Dear Patricia – thank you for your positive encouragement to make the changes to the document outlined in our previous response. Please find below a summary of the changes we have made. Reviewer comments are in black, our responses are in blue, and the *changed text in the manuscript are blue italics*. Line numbers indicating changes refer to the new version of the manuscript.

Reviewer 1 - Christian Mätzler

Reviewer 2- Alan Geer

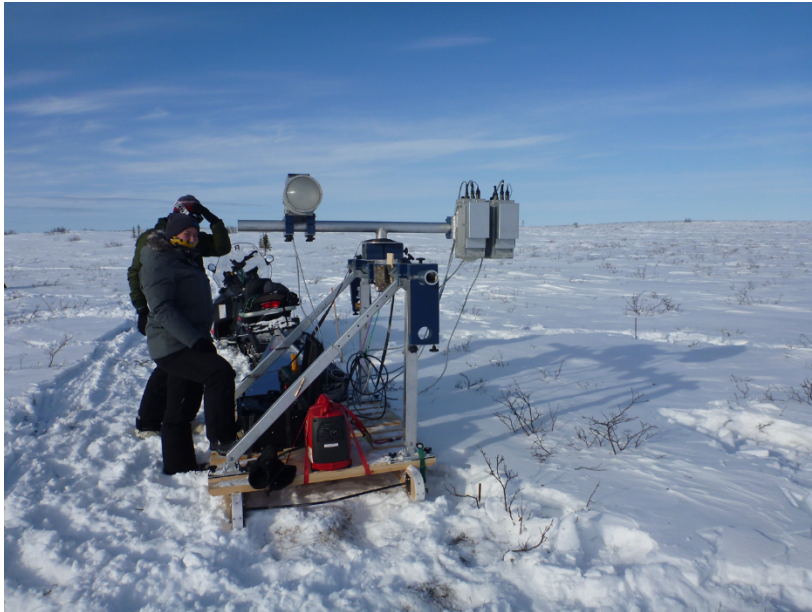
The objective of the study is not focussed on snow science, but on the search for a better use of microwave radiometer data from satellites in weather forecasting, especially in polar regions. Snow and ice surfaces produce the variable background of the atmospheric emission to be looked for. Different disciplines, dealing with atmosphere and cryosphere join here in a highly intricate way. Fortunately, the authors use up-to-date models (ARTS, SMRT) for simulating sensor signals at frequencies near 89, 118, 157, 183 and 243 GHz, i.e. at wavelengths roughly between 1 and 3 mm. Since snow-structure parameters cover a similar range, volume scattering by snow is dominant and can be highly variable. The selection of these frequencies, however, is not optimum for snow. It was based on the atmospheric properties to be sensed. The atmospheric window channels at 89, 157 and 243 GHz are highly sensitive to liquid-water clouds, to water vapour, and with increasing frequency also to ice clouds, the 118 GHz channels are used for temperature profiling around an O₂ line, and the 183 GHz channels are used for humidity profiling around a strong line of water vapour. Only the wing channels around these lines played a role here. In a future study, window channels at lower frequencies that are optimal for snow should be used as well. When reading the manuscript, it appears that the focus was more on snow than on the overall aspects. No information was given on the atmospheric opacity range at the given channels. Because the airborne system was optimised for the atmosphere, it is not surprising that the results were only suboptimal. Imaging microwave radiometers optimised for the surface use conical scanning with constant incidence angle. The authors found a way out of this problem by limiting the study to radiance from nadir direction. However, this limitation was a trap for various reasons as shown below.

These are included for the discussion record. However, the general reader may find the downwelling brightness temperature measurements from the airborne instrument more useful. These are given in the Appendix, Figure A1. This figure has been reordered according to frequency rather than instrument to be consistent with other figures). We disagree that these results are suboptimal: the challenges of point simulations vs areal observations will always exist and the purpose of this study was to demonstrate that we could explain the airborne observations through radiative transfer

simulations, and that we can account for the surface effects in observations of the atmosphere, which we have done. The text (line 73) has been amended to *'The purpose of this study is to demonstrate that radiative transfer simulations accounting for surface effects with SMRT can sufficiently explain the behaviour of observed airborne TB at these frequencies. This is required to improve assimilation of satellite data in numerical weather prediction but is challenging due to the spatial variability of snow at airborne measurement scales.'* to make the reader more aware of that we are addressing the point vs areal challenge head on.

The radiometer setup is shown in the figure below:

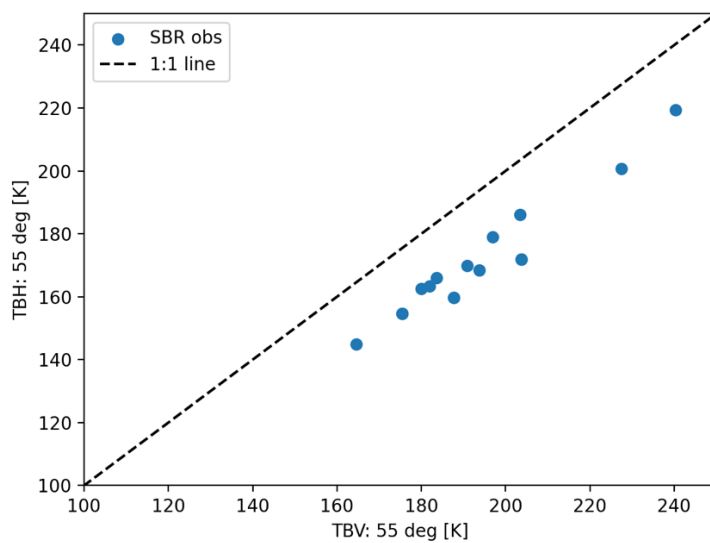
Discrepancies between surface and aircraft observations and changes in observations between different flights were interpreted by small-scale heterogeneity and by temporal variations. Radiometric data presented were taken at an unspecified aircraft altitude. Also, data taken with a surface-based instrument on a sledge at 89 GHz were transformed to flight altitude. I cannot understand how the setup measured the snow surface in nadir direction without distortion by shadowing of the sky and by its own radiation towards the footprint. It is much better to observe at a sufficiently large nadir angle (50° to 60° off nadir, as conically scanning satellite instruments do). Then the distortion by the instrument and its setup can be negligible, and additional information by the difference between vertical and horizontal polarisation can be obtained, e.g. to separate between specular and diffuse scattering. This would help in quantifying the effect of the ice lens. Transformation to nadir direction could still be done approximately by combining SMRT and ARTS. The surface-based instrument should also be used to measure the downwelling sky radiation (tipping curves for calibration, and to determine the zenith opacity of the atmosphere). I missed information on such measurements. Indeed, atmospheric and surface radiation are linked in many ways!

The aircraft altitude was approximately 500m –*'(approximately 500m altitude)'* has been added to the text in line 129. We have downwelling sky radiation from the aircraft measurements, as shown in Figure A1. While there may be differences between the atmospheric emission at the time of flights and the time of the ground-based measurements, these will be small at 89 GHz. The TB difference between flights was small and the variability within flights was of the order 5 K.

The use of a boom minimises the impact as much as possible. For the shadowing of the sky, there will be some specular component of reflection that will make the nadir measurement more sensitive to shadowing effects. However, the instrument is likely to be far from a black body and thus reflect the radiation far more than it will emit. Any metallic elements of the instrument will have reflectivities close to unity, so it may be appropriate to ignore the emission of the instrument and think of it as scattering the radiation. This means the TB measured will be larger than it would be without the instrument there, but the effect will be small. The results for the simulation of H and V shown below indicate that the error due to the radiometer set up is likely to be small.

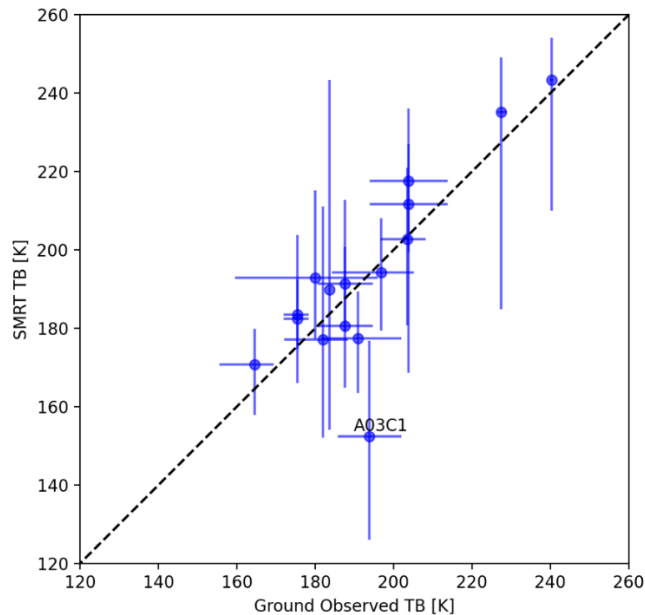
We do have measurements at 55 deg and there are differences between H and V polarisation as shown below.

In terms of the simulations, we had initially looked at both sets of measurements (nadir and 55 deg) but decided to focus only on nadir measurements to simplify the paper. Nevertheless, the 55 deg simulations are interesting in themselves to look at diffuse vs specular reflection and/or the impact of ice lenses, as Prof. Mätzler indicates above.

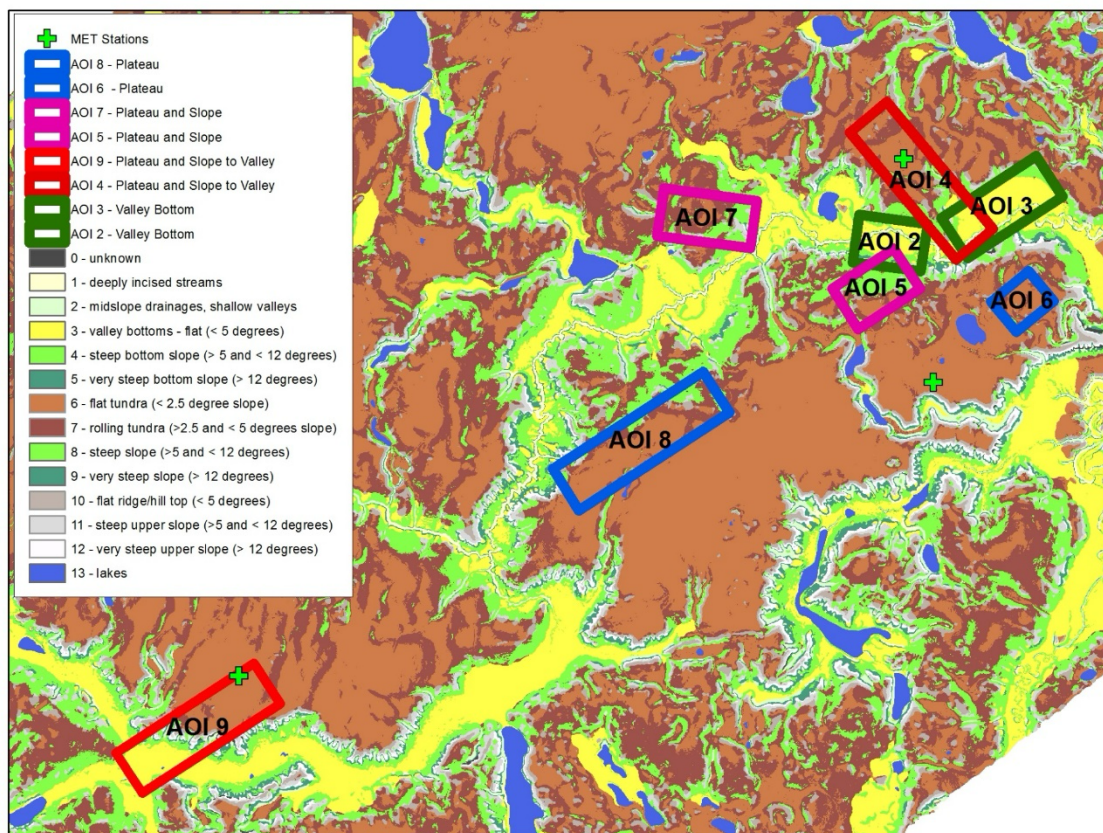
1) Figure 1: I miss geographic location and altitude range. It is unclear how rugged this terrain is, how steep the slopes and therefore how large the topographic effects are.

The details of the research basin will be added to the manuscript. Data were collected within the within the research basin of Trail Valley Creek (TVC), NWT, Canada (68°44' N, 133°33' W). The elevation range is 9 to 187 m.a.s.l and the topography is mostly gently rolling slopes with some deep

Text added (line 92) is *'The elevation range is 9 to 187 m.a.s.l and the topography is mostly gently rolling slopes with some deep valleys (Marsh et al., 2010). Further details about the vegetation characteristics are available in Grünberg et al., 2020'*.

A more detailed classification of Figure 1 is shown below for discussion purposes. Slopes were generally less than 12 degrees, and although steeper slopes were present (dark green or white in the figure below), they formed a small proportion of the scene. We chose a simplified version of this figure for the manuscript in order to provide a more concise representation.

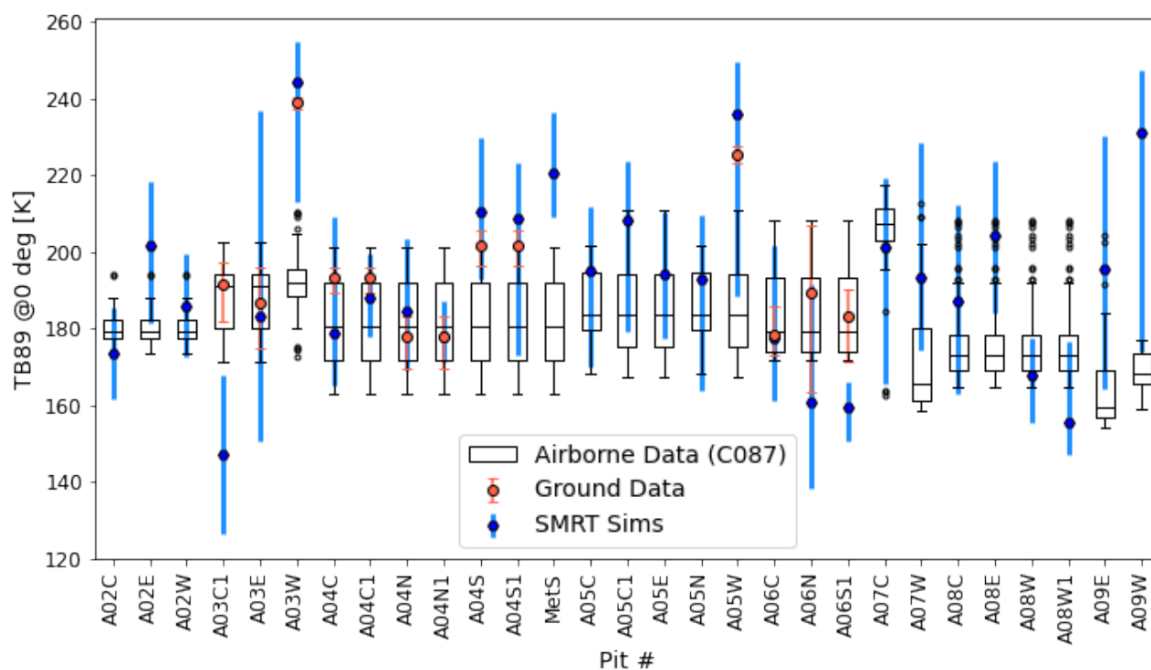
4) There could be some more investigation of the way the temperature profile is determined, and whether this has any bearing on the radiative transfer uncertainties. Lines 168-170 describe a linear extrapolation from the air temperature (ultimately from dropsondes?) through the snowpack to a stable lower layer temperature. Is this sufficient to represent the relative complex dependence of the snow temperature profile on the surface air temperature, particularly its insulation properties and speed of heat transfer? For example, when trying to explain the drop in brightness temperature between flights C087 and C090, could this be relevant? Looking at Figure 9, at the time of the C090 flight, could the snow still be cold after a night that dropped below -25 degrees C, and hence has not yet caught up with the rapid rise in the air temperature?

The figure below is from an earlier draft of the paper that used measured pit temperatures rather than interpolated from the air temperature. Although other amendments were also made (e.g. inclusion of missing ice lens information in two pits), a comparison between the figure below and Figure 7 in the paper illustrates that the effects of temperature representation are minor.
